INDEPENDENT EXPERT ADVISORY PANEL FOR MINING

DENDROBIUM COAL MINE LONGWALL 21A SUBSIDENCE MANAGEMENT PLAN

2 July 2024

Report No: IEAPM 202407-1

Figure 4: Predicted and measured vertical surface displacement along a transverse line near the mid-length of LW21 and along the centreline of LW21 (MSEC, 2023b)

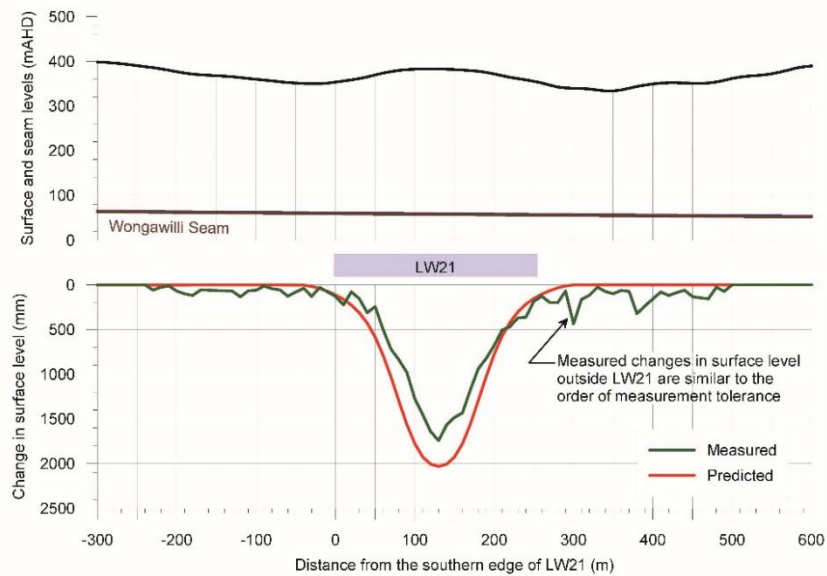
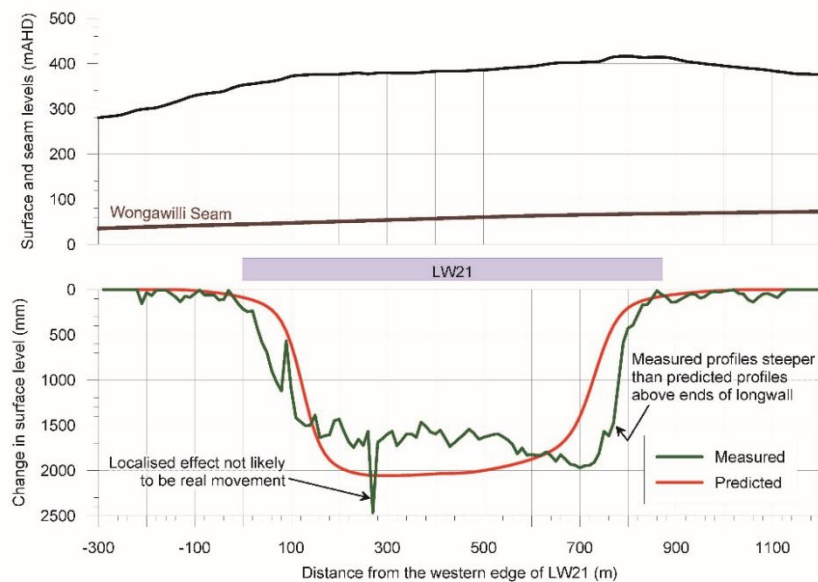
Analysis undertaken by the Panel based on **Figure 4** indicates that measured maximum tilt on the flanks of the transverse line was of the order of 18 mm/m compared to predicted of the order of 25 mm/m. The measured tilt along the centreline at the finishing end (western end) of LW21 was of the order of 10 mm/m compared to predicted of around 18 mm/m (noting that the horizontal scale on the longitudinal section is compressed by a factor of about 0.6 to that of transverse section). Measured maximum tilt on the starting flank (eastern end) of the centreline was higher than predicted, but still only of the order of 18 mm/m and, therefore, not greater than that predicted for the transverse section. Hence, on a percentage basis, the Panel does not agree that the measured tilts are similar to predictions; they differ by 50 to 80%. However, in terms of the resulting subsidence impacts and consequences, the differences are not material in the LW21 setting and, in fact, for the most part are more favourable from an environmental perspective.

Figure 5: Modelled and observed groundwater levels at S1969.

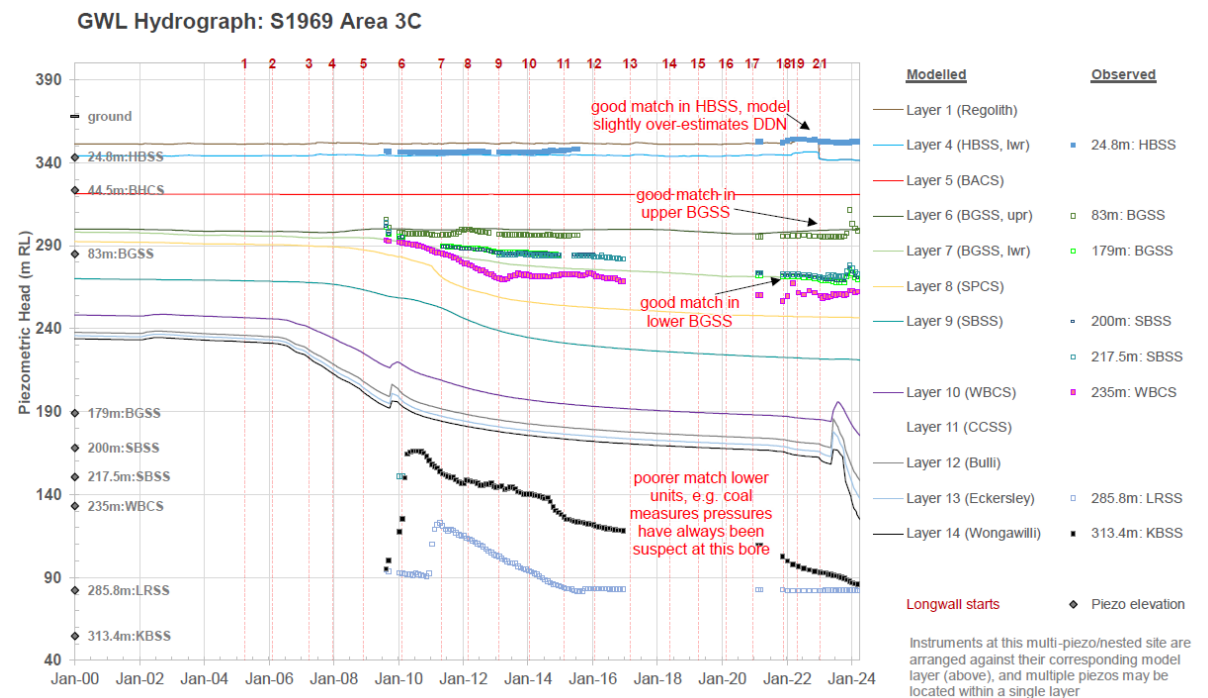
It appears that the model requires some refinement in Area 3C for recharge and aquitard parameters, and potentially the inclusion of different parameters to replicate the multiple dykes in the deep model layers.

Figure 6: Swamp monitoring sites (paired shallow groundwater and soil moisture sites)

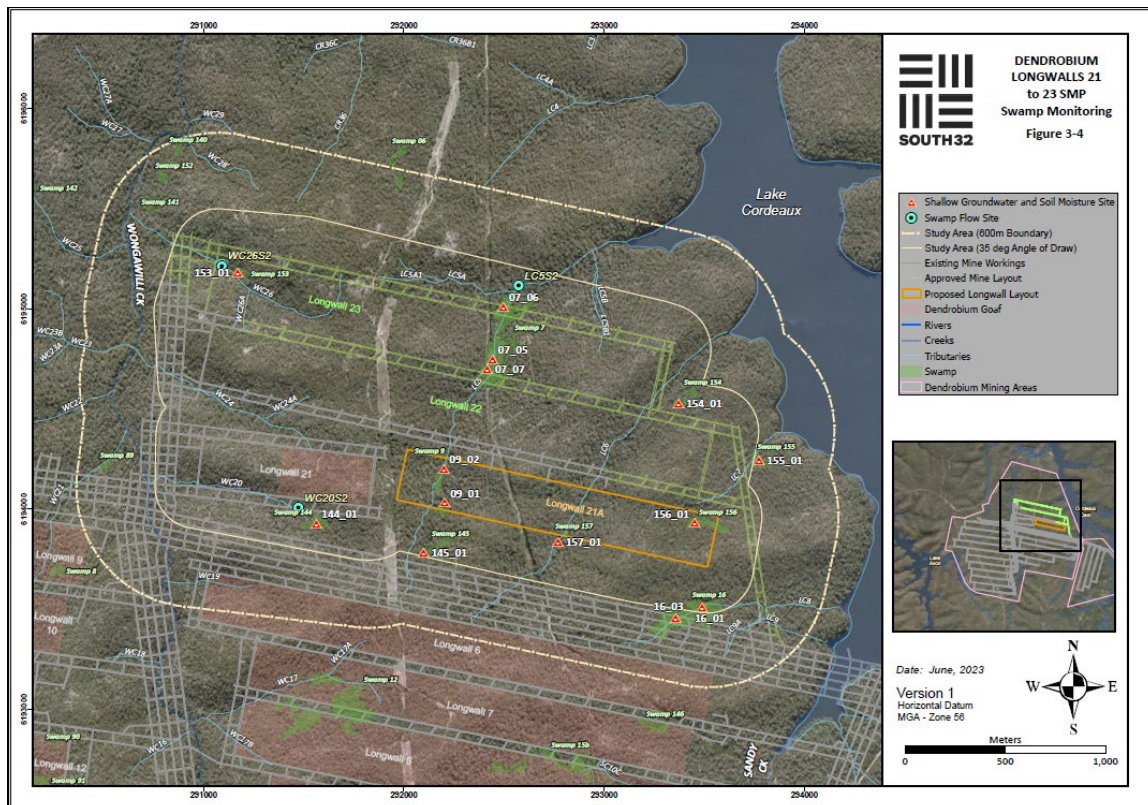
The perched groundwater and soil moisture monitoring network in the upland swamps provides adequate spatial coverage to assess any mining induced impacts associated with the extraction of LW21A. However, the depth coverage is lacking as there are no nested standpipes adjacent to any of these swamps to confirm whether there is connectivity between perched groundwater in the colluvium/weathered rock and the regional groundwater in the Hawkesbury Sandstone. The Panel recommends a nested monitoring site at the edges of each of Swamps 7 and 9 to monitor perched groundwater levels in the weathered rock and the regional water table in the sandstone to better assess potential mining induced impacts. These should be paired with (or close to) existing swamp monitoring locations.

Figure 8: Geological structure and seam floor contours in the vicinity of LW21A (South32, 2024a)

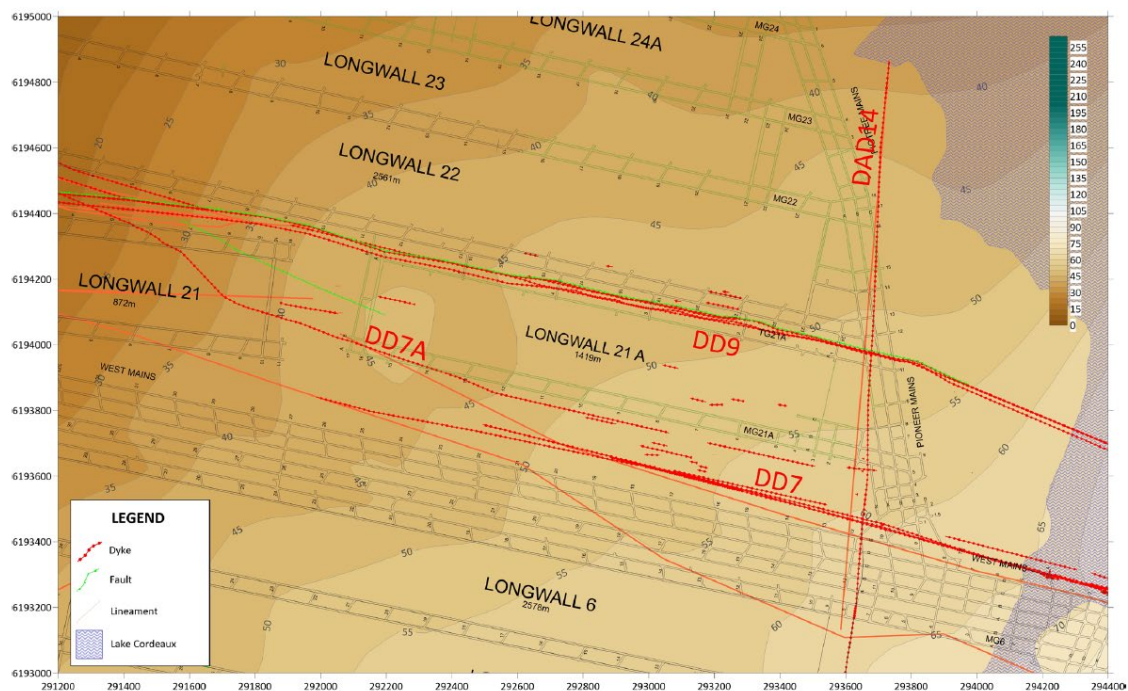
The Panel notes that the number and spacing of mapped geological structures in Area 3C, shown in **Figure 8**, are greater than in Area 3B. However, South32 (2024a) provides details of extensive investigation of geological structures and notes that LW21A has been oriented between the two major dykes DD9 and DD7, neither of which have caused anomalous water make when intersected previously (by first workings). Similarly, two smaller dykes - DAD14 striking north-south at the eastern end of the longwall and DD7A – have not caused anomalous water inflow in first workings. The Panel has been advised that studies are ongoing into the dykes in the vicinity of LW21A. Monitoring of all dykes and water make is planned to continue during extraction.
